ADDENDUM NO. 2

TO: PLANS AND SPECIFICATIONS FOR STATE OF MISSOURI

New Outdoor Pavilion
Missouri Veterans Home
St. James, MO
PROJECT No.: U2610-01

E-100

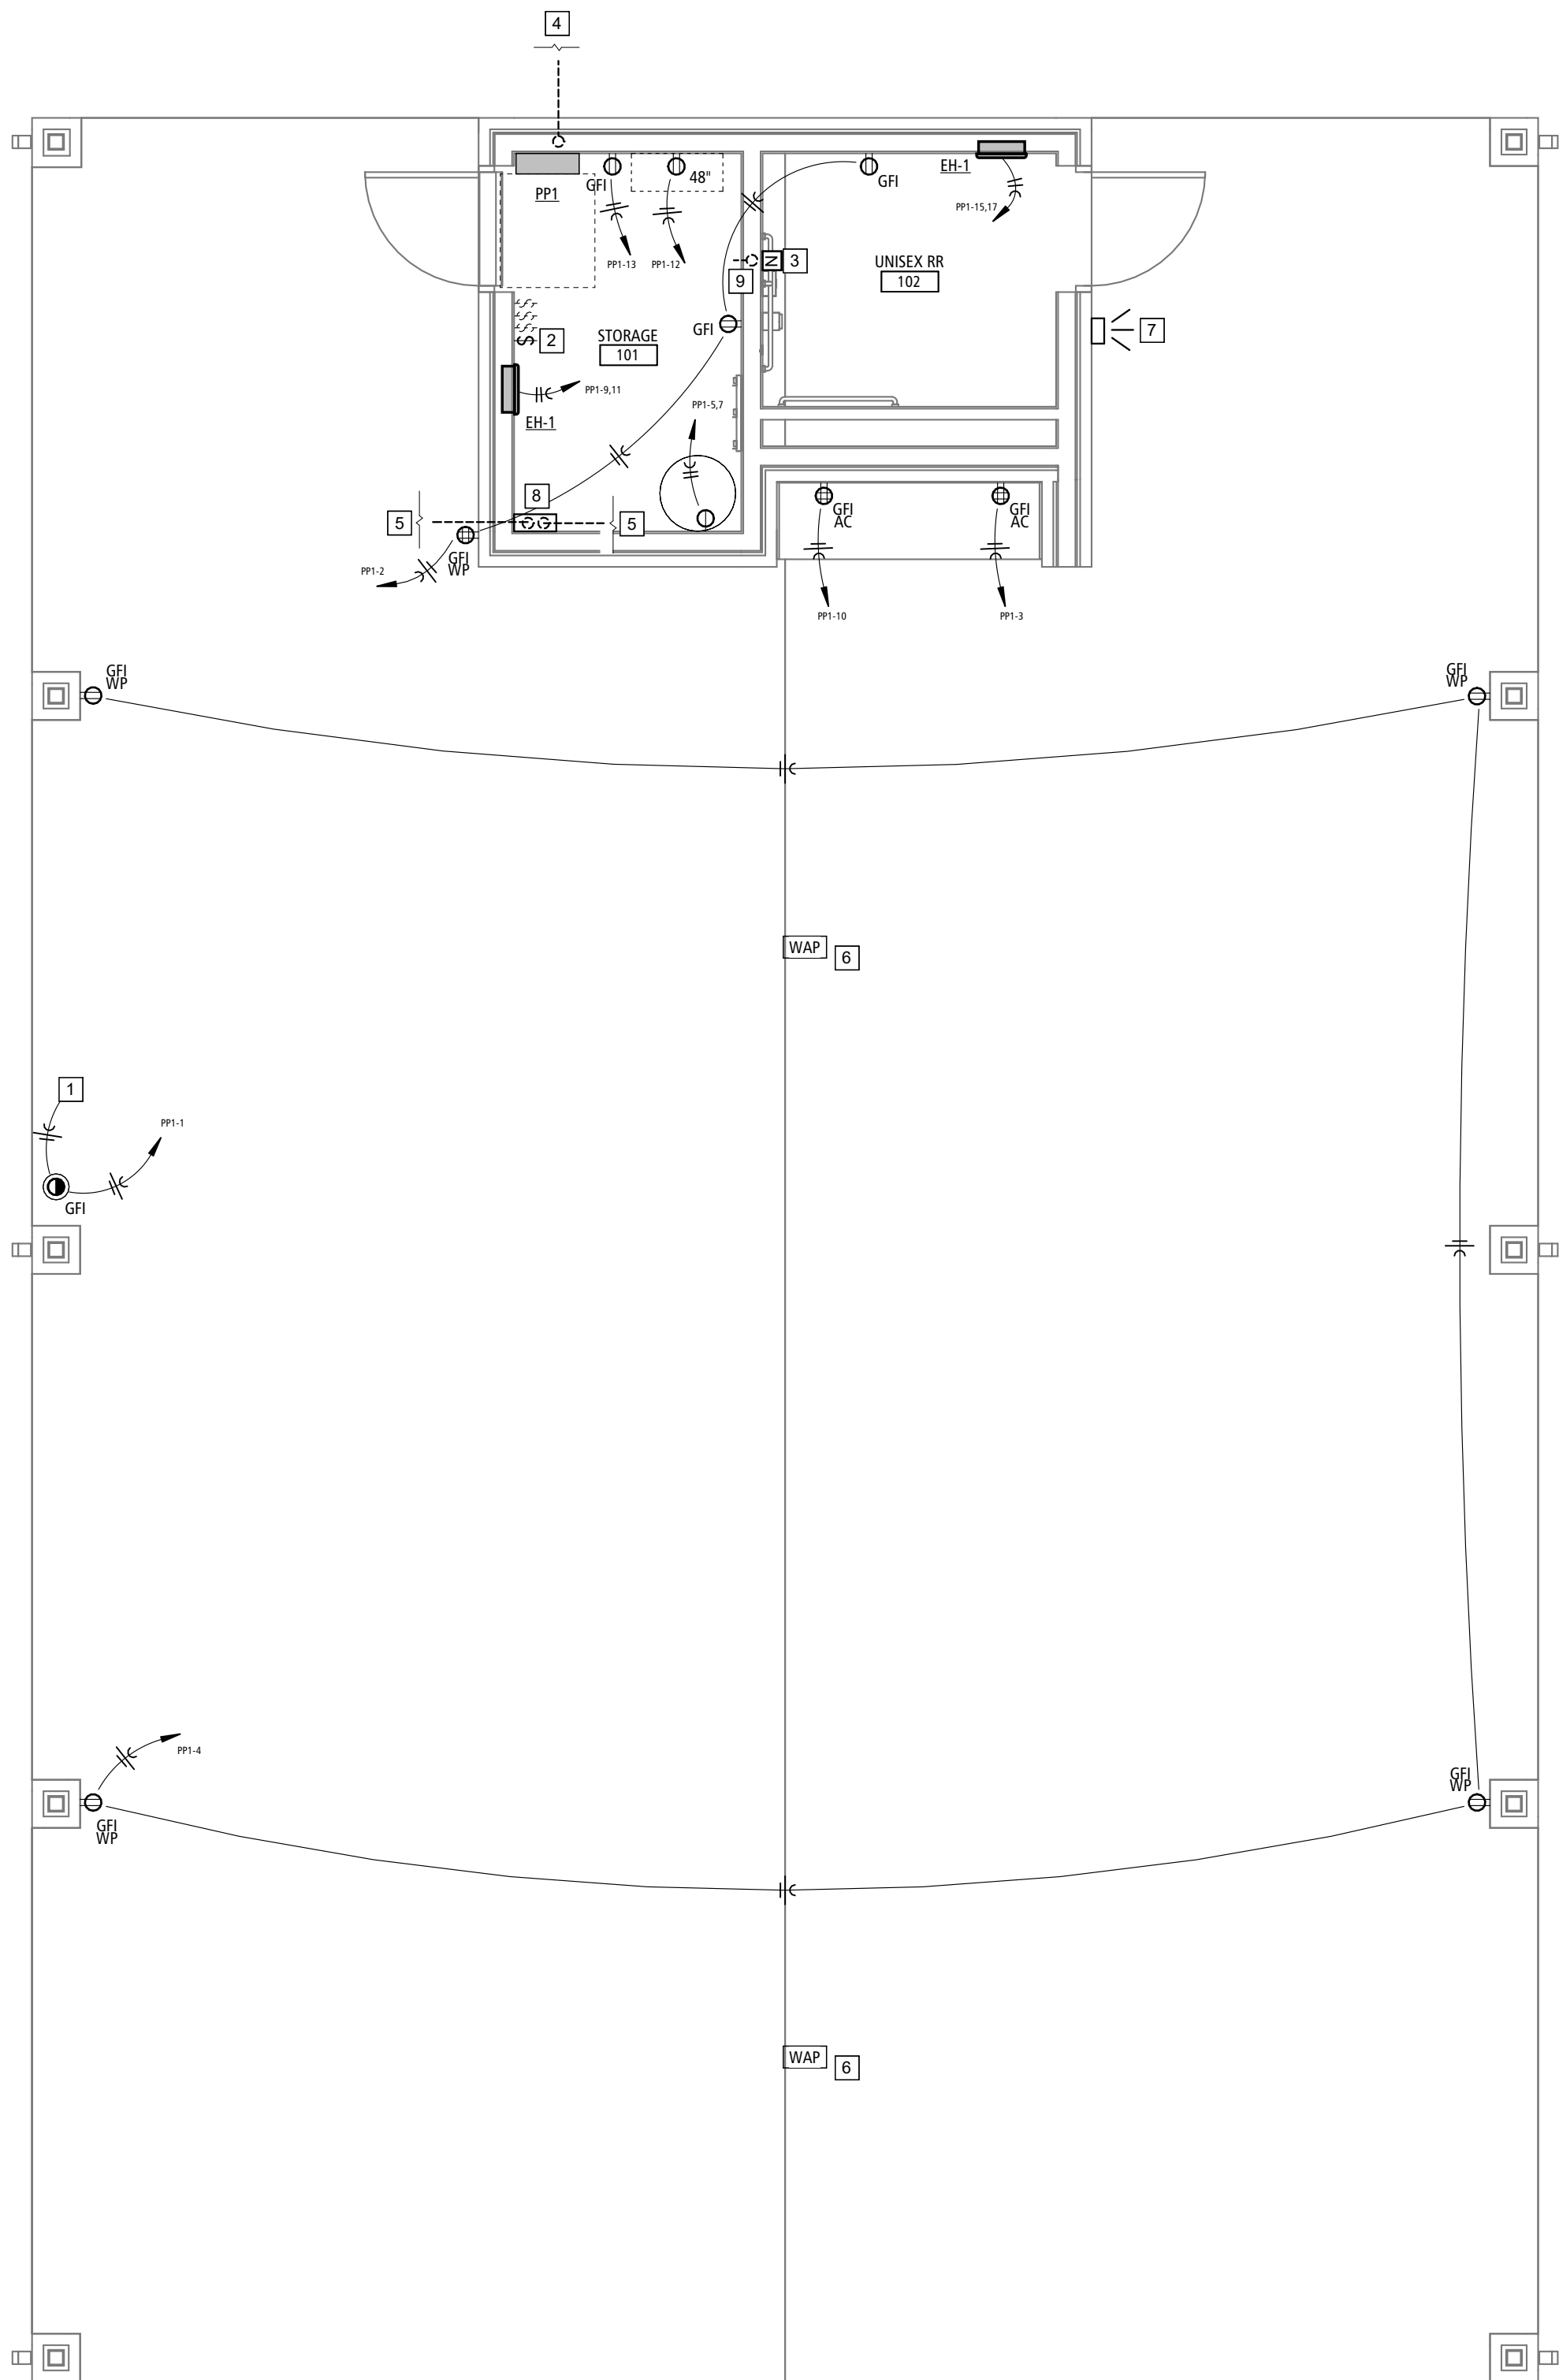
2. SHEET A-300
 - a. REMOVE comment for DOOR NO. 102 in DOOR SCHEDULE.
 - b. REVISE leader notes for cast stone band on Wall Sections #1, 2, 3 and 6.
3. SHEET E-100
 - a. REMOVE AND REPLACE **Note 3** of **Electrical Plan Keynotes** as follows:
INSTALL JUNCTION BOX WITH COVER PLATE FOR FUTURE NURSE CALL PULL STATION. CONFIRM FINAL MOUNTING HEIGHT AND LOCATION WITH OWNER. ROUTE 3/4" CONDUIT TO ABOVE DROP CEILING IN RESTROOM.
 - b. REMOVE AND REPLACE **Note 7** of **Electrical Plan Keynotes** as follows:
INSTALL FLUSH MOUNT EXTERIOR JUNCTION BOX WITH COVER PLATE FOR FUTURE NURSE CALL ALARM LIGHT. ROUTE 3/4" CONDUIT TO ABOVE DROP CEILING IN RESTROOM.
 - c. REMOVE AND REPLACE **Note 9** of **Electrical Plan Keynotes** as follows:
EXTEND CONDUIT STUB OUT ON MECHANICAL ROOM SIDE FOR FUTURE WIRE PULL, IF NEEDED. INSTALLED OPPOSITE THE JUNCTION BOX FOR FUTURE NURSE CALL.

- INSTALL JUNCTION BOX WITH COVER PLATE FOR FUTURE NURSE CALL PULL STATION. CONFIRM FINAL MOUNTING HEIGHT AND LOCATION WITH OWNER. ROUTE 3/4" CONDUIT TO ABOVE DROP CEILING IN RESTROOM.
